VENDOR ITEM CONTROL DRAWING

UNLESS OTHERWISE SPECIFIED ALL DIMENSIONS ARE IN INCHES DIMENSIONS IN BRACKETS [] ARE FOR REFERENCE ONLY INTERPRET DRAWING AS PER ASME Y14.5-1994 OR Y14.5-1975					
DIMENSIONAL TOLERANCES	ANGULAR TOLERANCE	FINISH	DRAWN BY	CHECKED BY	DATE
X ± 0.060	± .5°	125/	P. SCHNEIDER	C. AMARITO	4/3/2012
.X ± 0.030				O. SINGH	10/2012
.XX ± 0.015				A. HUSSAIN	10/2012
.XXX ± 0.005				S. SHARMA	10/2012
BREAK EDGES & SHARP CORNERS 0.005 MIN. TO 0.020 MAX				N. GMUR	10/2012
				E. CHESWICK	10/2012
NEXT ASSY: SR-DG-BL-3000	PROJECT: NSLS-II	SCALE: SEE DWG VIEW	WBS# 1.03.04.05.04	STORAGE RING DIAGNOSTICS, BEAMLINE WINDOW, X-RAY EXIT, 3PW SR-DG-BL-1046 DRAWING PART NUMBER	
THIRD ANGLE PROJECTION			ESH&Q RISK LEVEL A-2		REVISION A
			SHEET 1 OF 3

FYI, this is the email from Mike Gaffney indicating that Safety Engineering has no pressure safety issues with the installed exit window in C22.

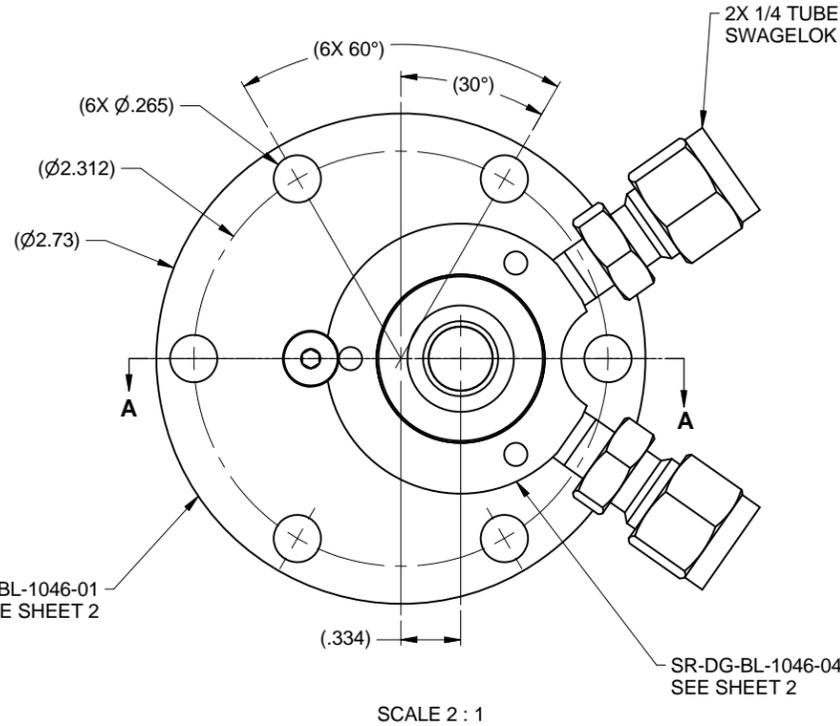
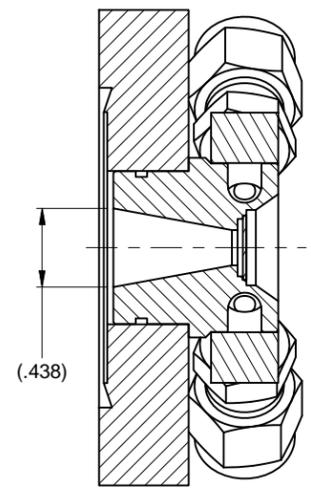
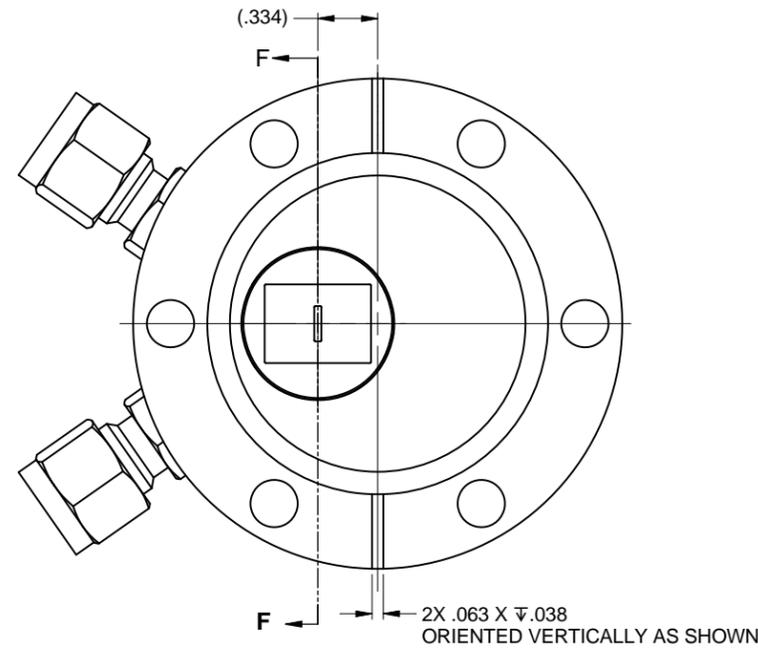
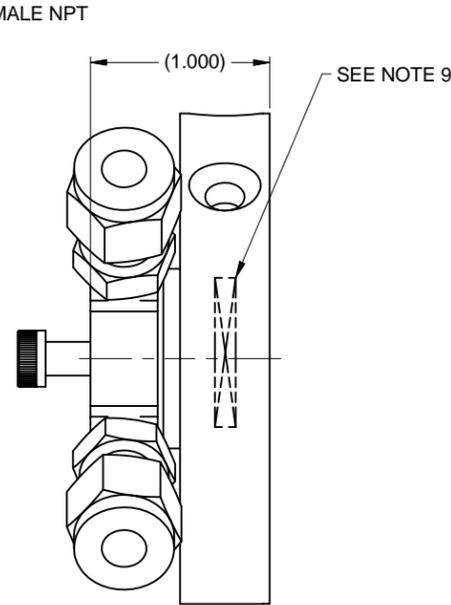
After reviewing the material that Bernie Kosciuk sent me, Safety Engineering does not have any pressure safety issues with the use of the installed window.
It is recommended that if prior to installing a replacement window, that prior to any Helium leak test and thermal cycling test, a different pressure test (both sides) is performed on the window.
